NCSX

Follow-up Analysis performed on the
FPA Station 3 following its FDR

NCSX-CALC-18-001-00

3 August. 2007

Stage 3 Modular Coil Supports
Reaction Loads at Base (Hilman Rollers)
Gravity Loads Only

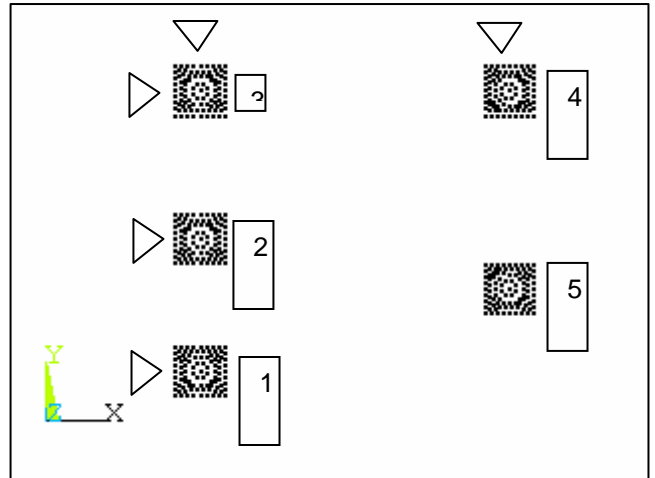
The spreadsheet below shows the reaction loads at the Hilman rollers for the Modular Coil HP Support with gravity loads (25,000 lbs). The largest value is just under 10,000 lbs. Each of the five Hilman rollers are 8 ton units.

Figure 4.1 *Mechanica* FEA analysis of VV support

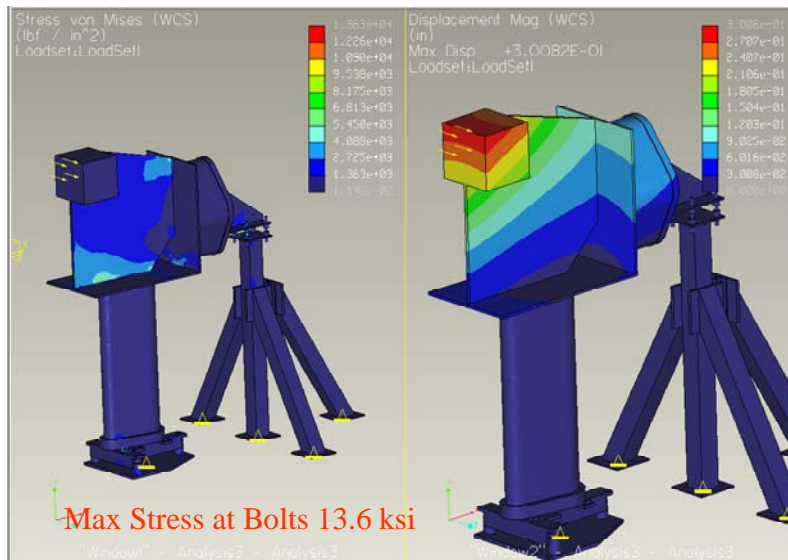
The analysis of the vacuum vessel with lateral load acting on it was made using a FEA model (see Figure 4.1) that included the vertical and horizontal ports along with a simplified representation of the VV shell, mimicking the vessel weight and CG location. For the condition of the vessel gravity load plus 1000 lb lateral load resulted in a high stress of 14 ksi occurring in one of the three threaded studs that are used to anchor the base support to the floor. The studs are 1-3/4" grade B7 alloy steel with 125 ksi ultimate and 105 ksi yield stress, providing a 41.7 ksi allowable (1/3 Sult).

Figure 4.2 ANSYS FEA analysis of VV support

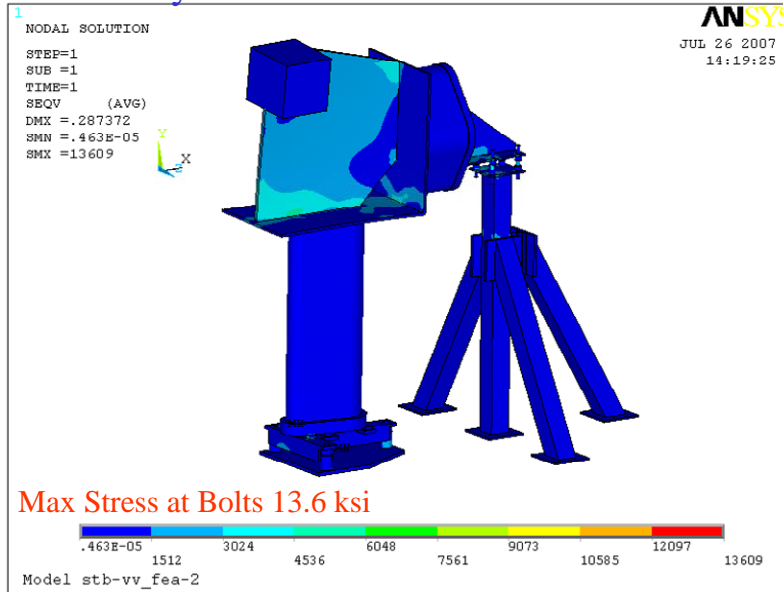
A confirmatory analysis was made on the same model using ANSYS and the same maximum bolt stress was determined (see Figure 4.2 below). The local peak stress is shown in figure 4.3.
